Petrotomics Company

Reference: Alternate Concentration Limits Application - Response to open issues 1, 4, and 5
- Source Material License SUA-551

PETROTOMICS TAILINGS FACILITY
APPLICATION FOR ALTERNATE
CONCENTRATION LIMITS
SOURCE MATERIAL LICENSE SUA 551
RESPONSE TO NRC OPEN ISSUES 1, 4, AND 5

RESPONSE TO NRC OPEN ISSUES 1, 4, AND 5

PETROTOMICS COMPANY
Figure 1-13
Millions of Kg of TDS Recovered

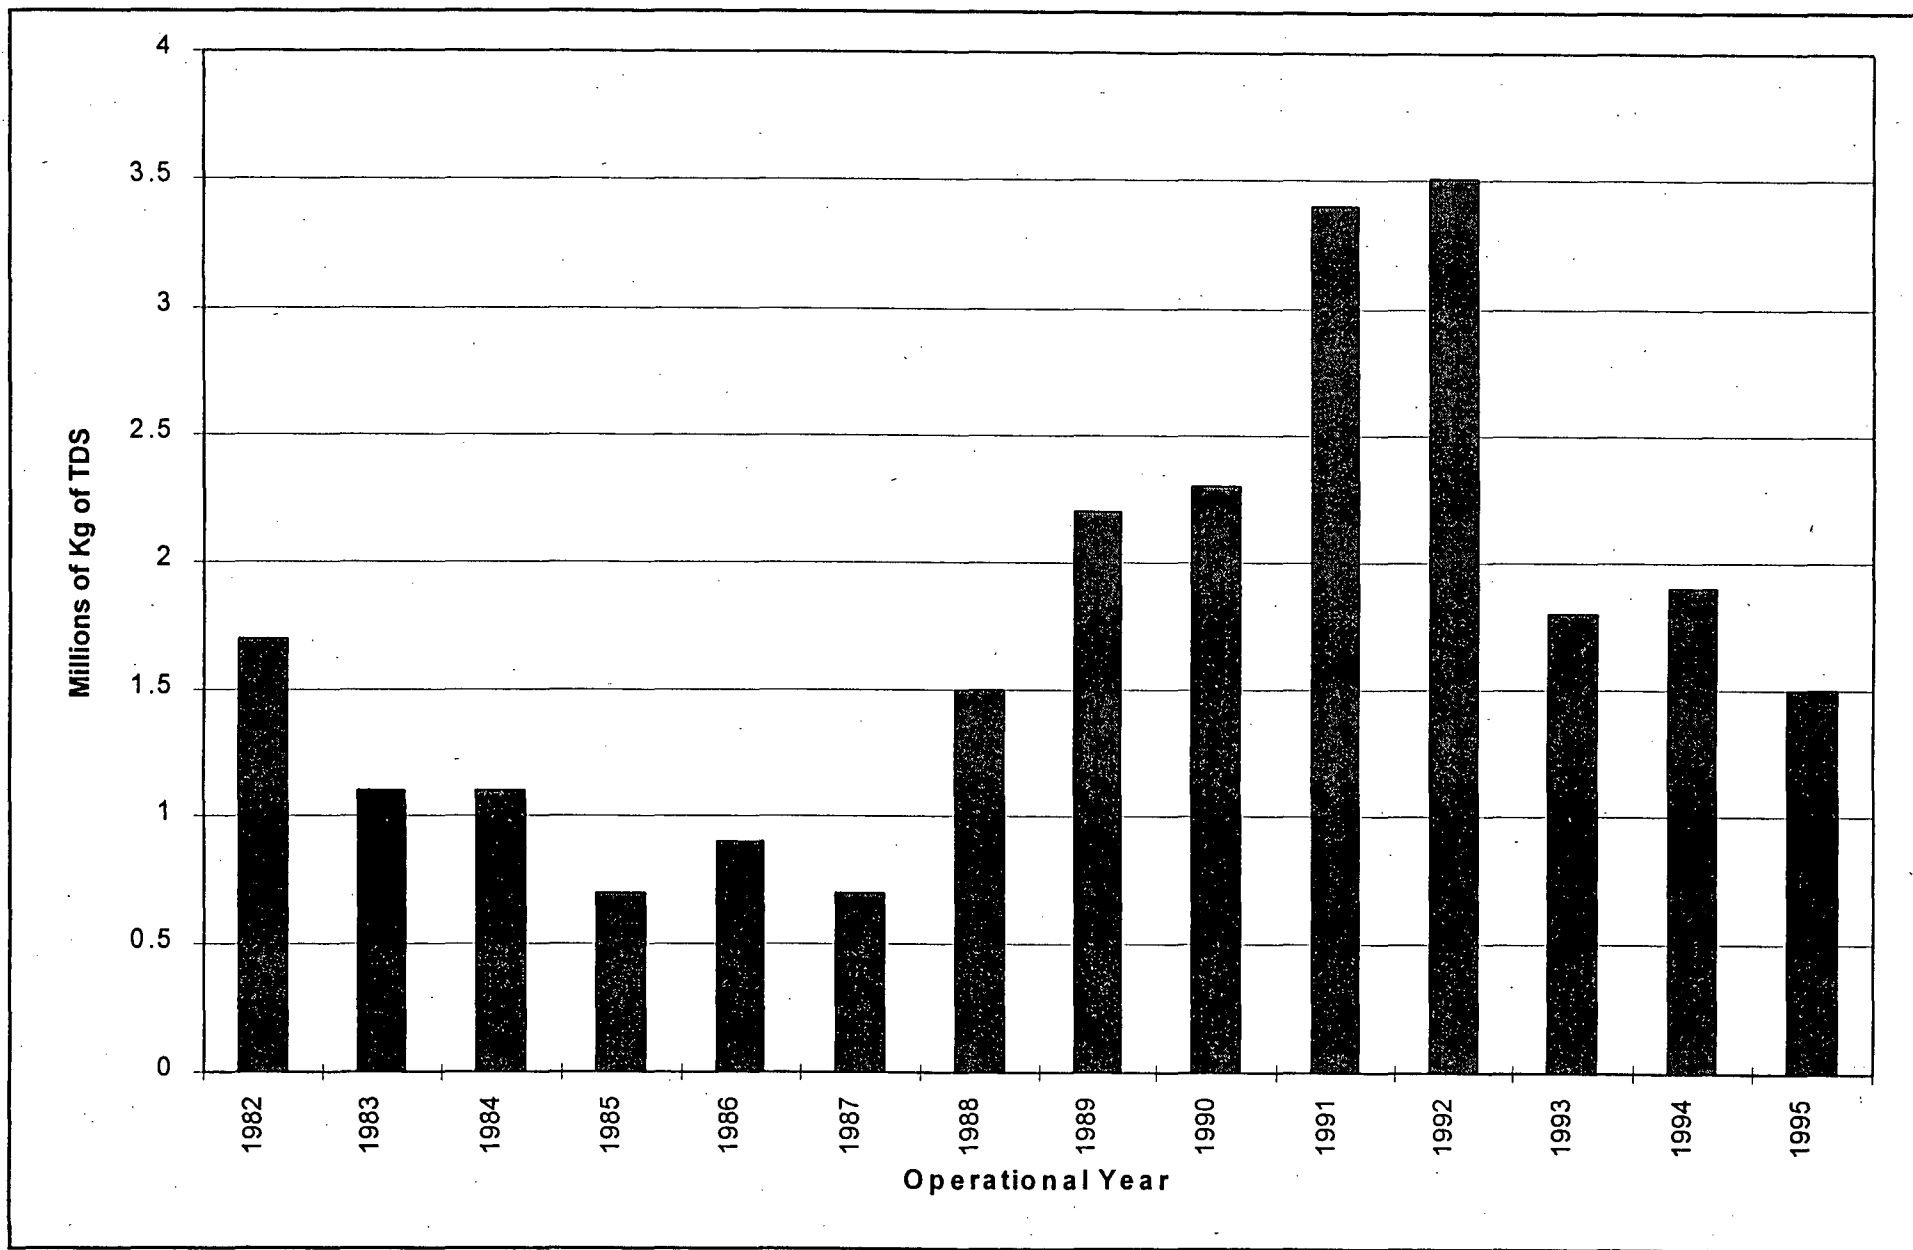
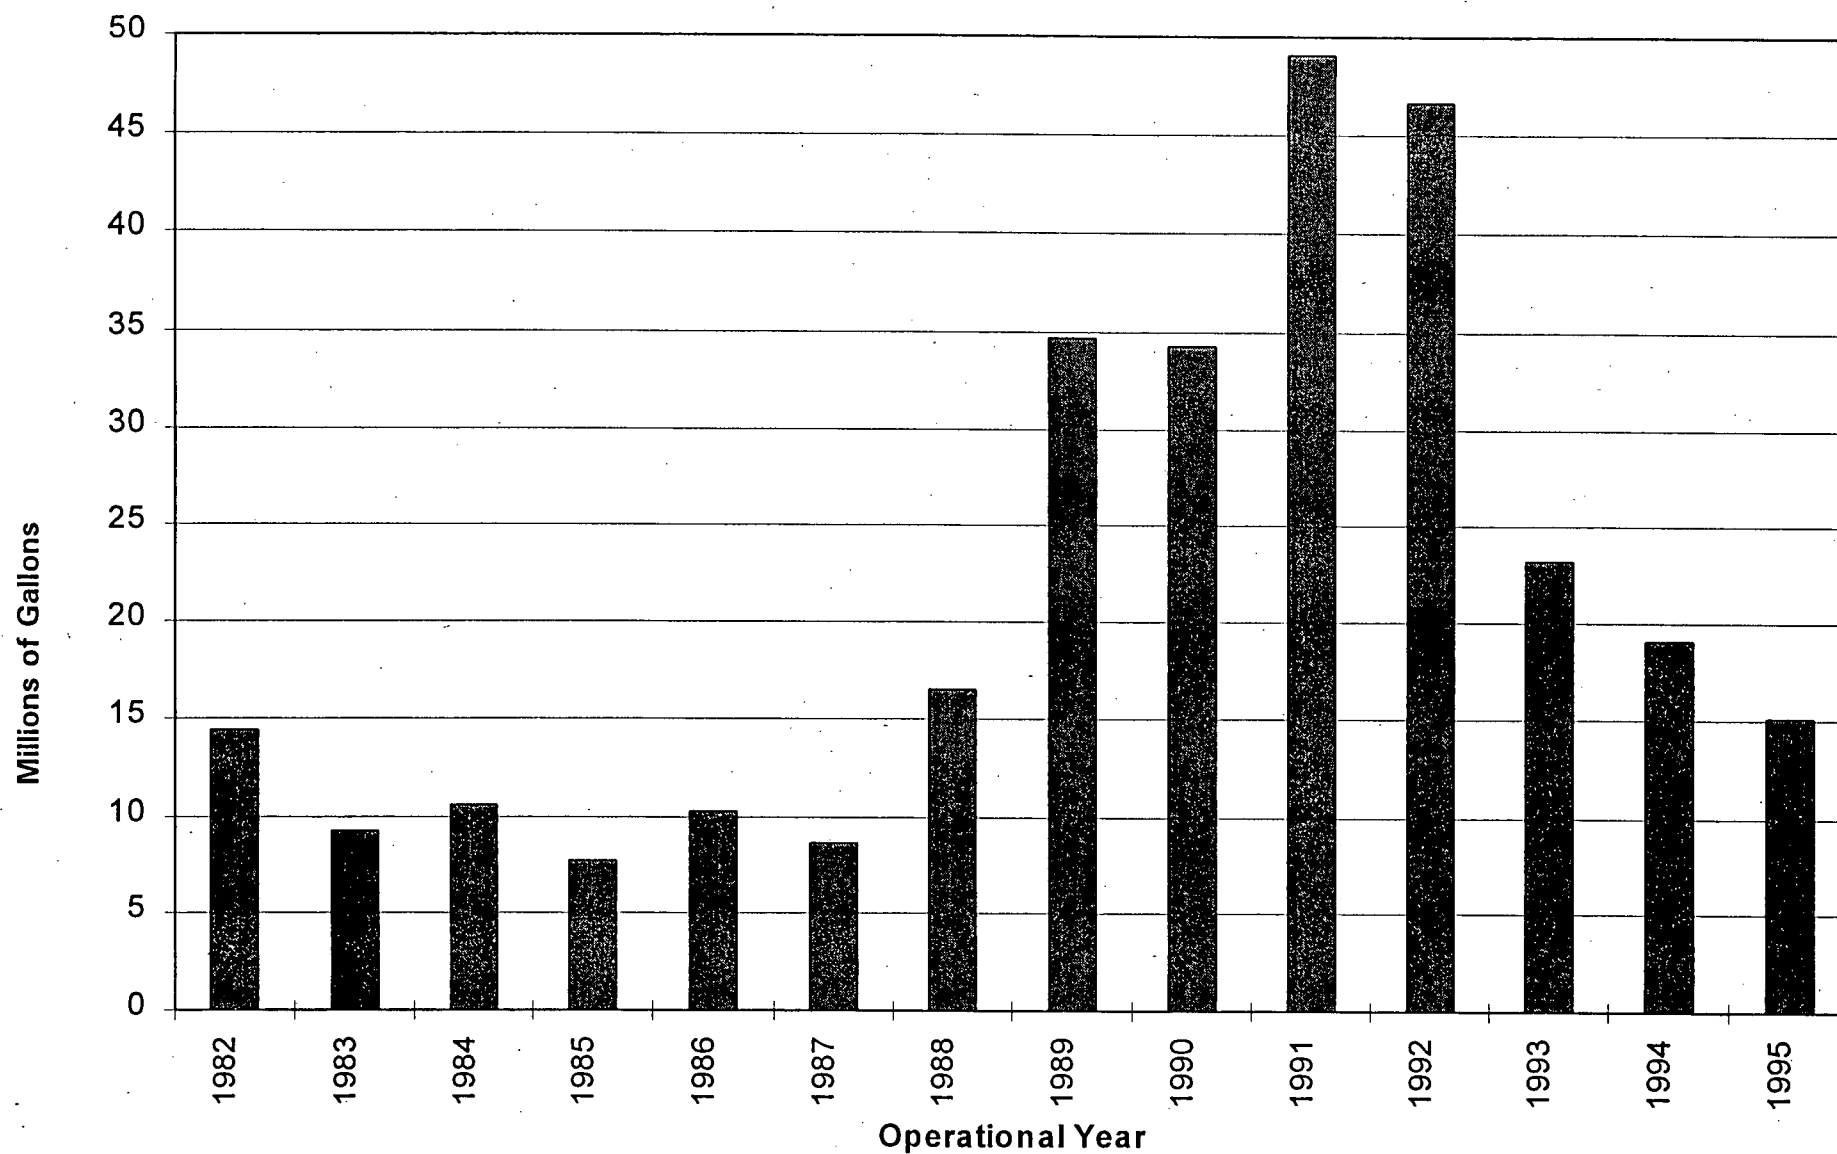
ACTION NEEDED: Petrotomics should propose ACL values for hazardous constituents of concern which are ALARA. These values should be based on an assessment of constituent concentrations levels achieved to date. Petrotomics should use data from wells outside the tailings impoundment to select site ACLs and should exclude well 12DC from consideration as a POC.

Operation of the seepage mitigation plan and the CAP have resulted in the recovery of more than 26 million kilograms of tailings-derived constituents (Figure 1-13), and over 300 million gallons of solution (Figure 1-14). All of the recovered solution has been returned to the tailings impoundment and evaporated at the surface. Sludges and salts left behind by evaporation will be reclaimed in conjunction with the tailings reclamation.

PETROTOMICS COMPANY
Figure 4-3
1996 and 1997 Radium Data

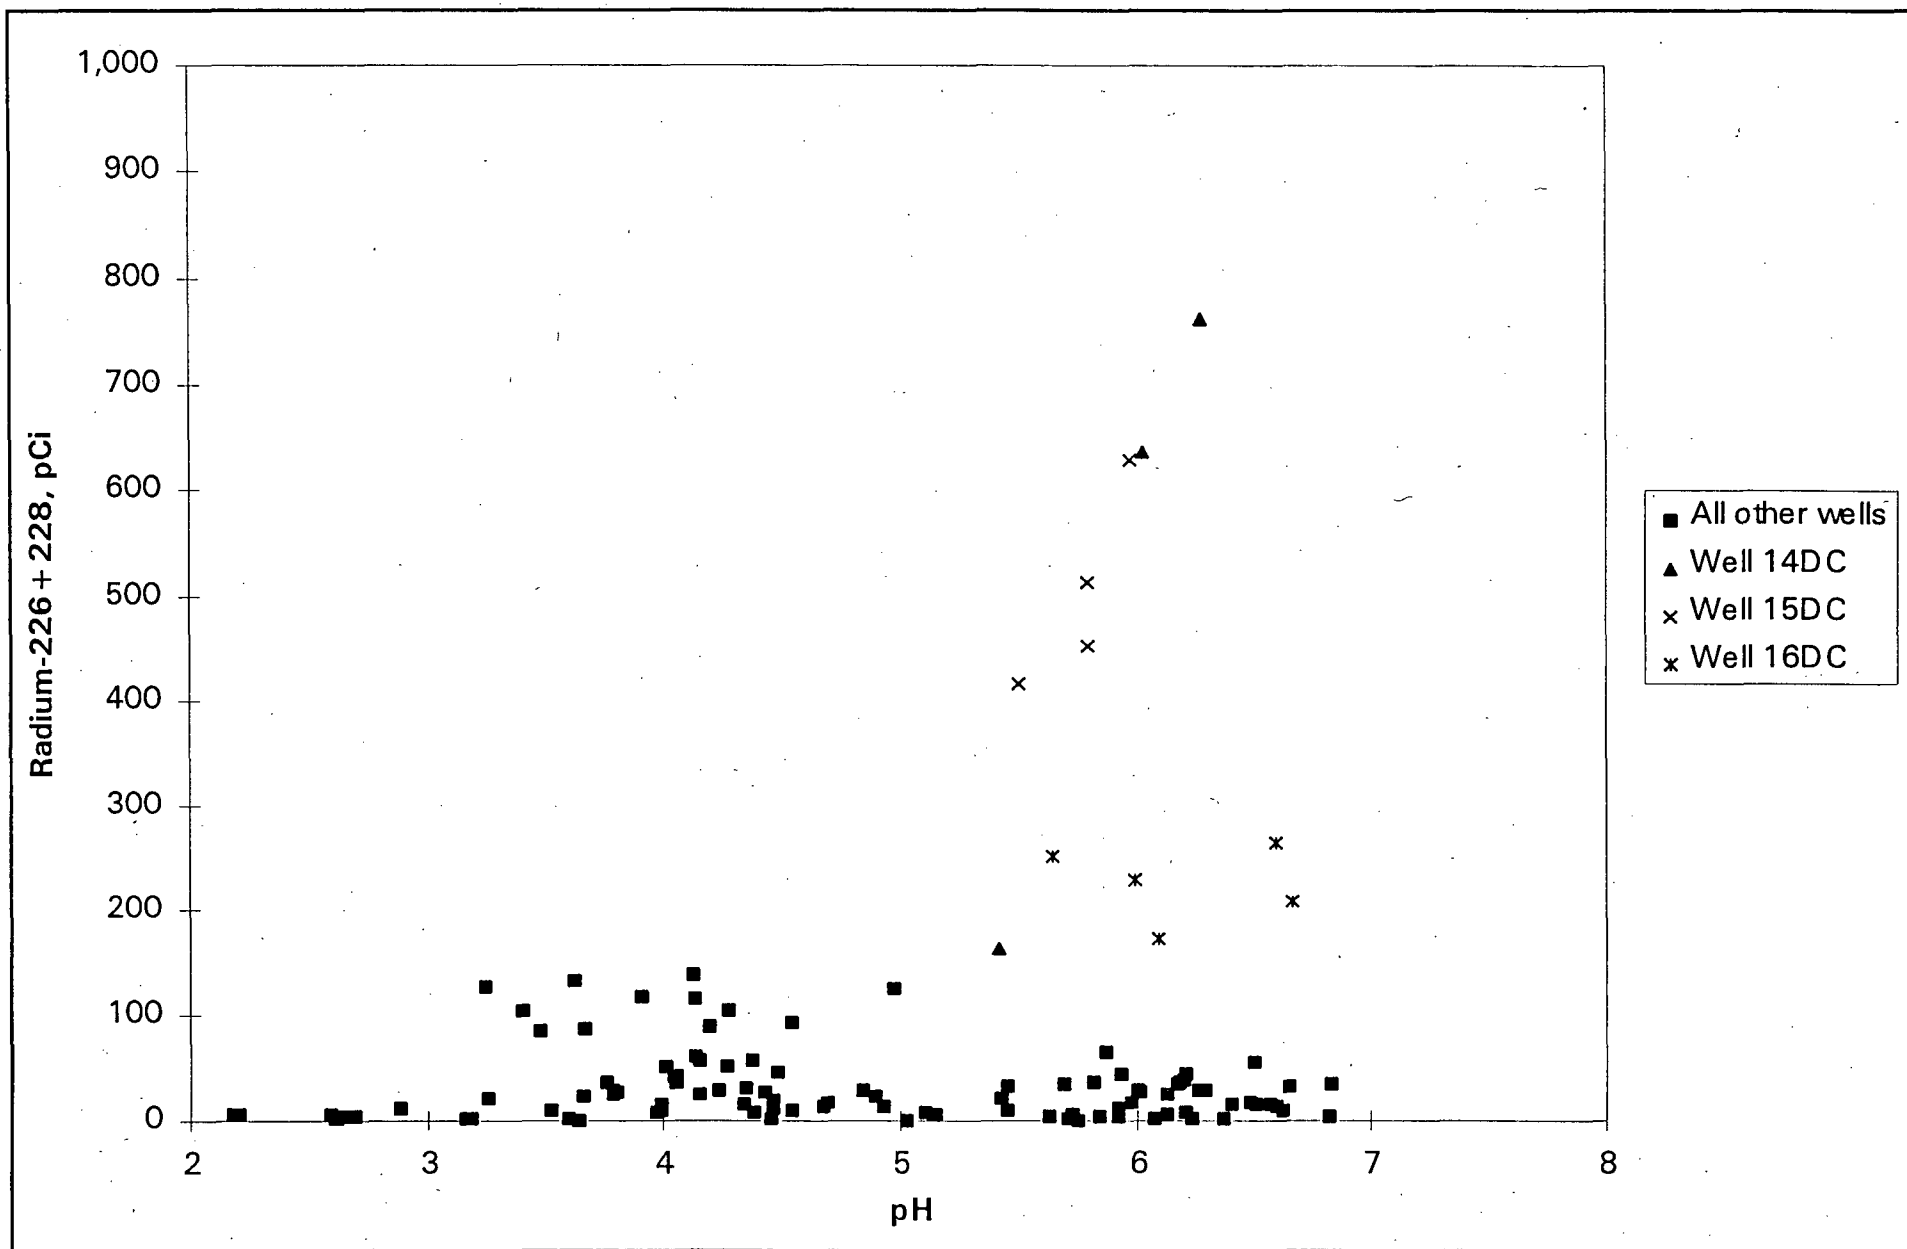
NRC (1997) observed that “for at least some of the constituents (e.g., cadmium and radium), pH and/or sulfate may not be useful predictors of constituent attenuation.” The following discussion provides additional data to clarify the relationship between pH/sulfate concentrations and cadmium and radium concentrations.

Radium concentrations during 1996 and first quarter 1997 are illustrated in Figure 4-3. Only three wells with pH above 4, 14DC, 15DC, and 16DC, had elevated radium concentrations. All of these wells are located in the ore zone (Figure 4-4). The two wells with the highest radium concentrations (14DC and 15DC) also had sulfate concentrations in excess of 6,000 mg/L. Radium concentrations in samples with pH greater than 4 and sulfate less than 6,000 mg/L do not display a simple correlation with pH or sulfate because of the naturally elevated radium concentrations caused by uranium ore. Radium concentrations in the Shirley Basin have been reported to be as high as 1,700 pCi/L (Lowry, 1973).

FIGURE 4-5 SCALE 1" = 1500' DATE: OCT. 1997

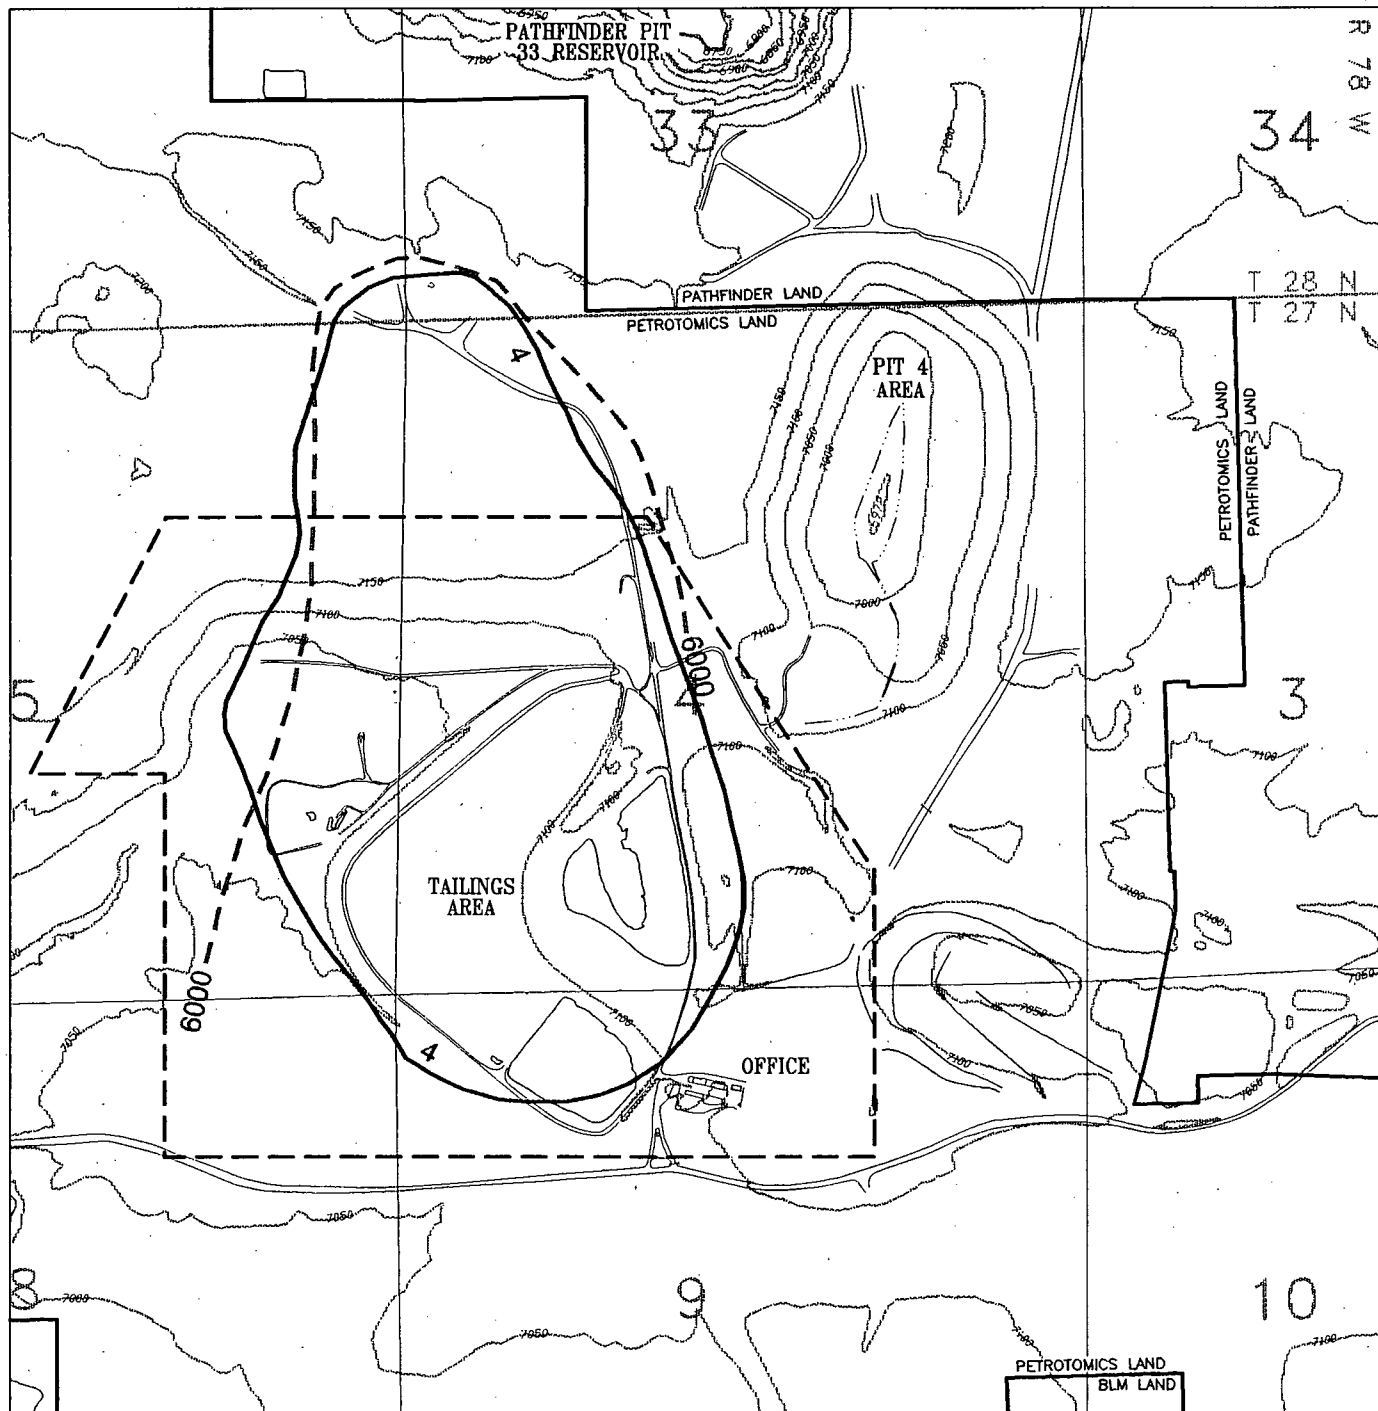
ACTION NEEDED: Petrotomics should address the effects of dispersion and mixing with uncontaminated ground waters with respect to gypsum equilibrium. A fate and transport analysis for sulfate should be provided for the 1,000-year closure period that incorporates gypsum equilibrium, dispersion, and mixing with uncontaminated ground water. Petrotomics is requested to re-examine the pH/sulfate relationship with regard to constituent attenuation using a larger statistical database of well data to verify 1995 trends in constituent concentration, pH, and sulfate.

The pH equal to 4 and sulfate equal to 6,000 mg/L contours for the Upper Sand were plotted for fourth quarter 1990 (Figure 4-5), for 1995 (Figure 4-6), and for first quarter 1997 (Figure 4-7). Fourth quarter 1990 represents the earliest time at which the plumes could be defined, whereas first quarter 1997 represents more recent conditions. It is clear from comparison of Figures 4-5 through 4-7 that sulfate equal to 6,000 mg/L contour has covered a larger area than the pH 4 contour. The changes in the contours between 1990 and 1997 were caused by the corrective action program (Figures 4-5 and 4-7).
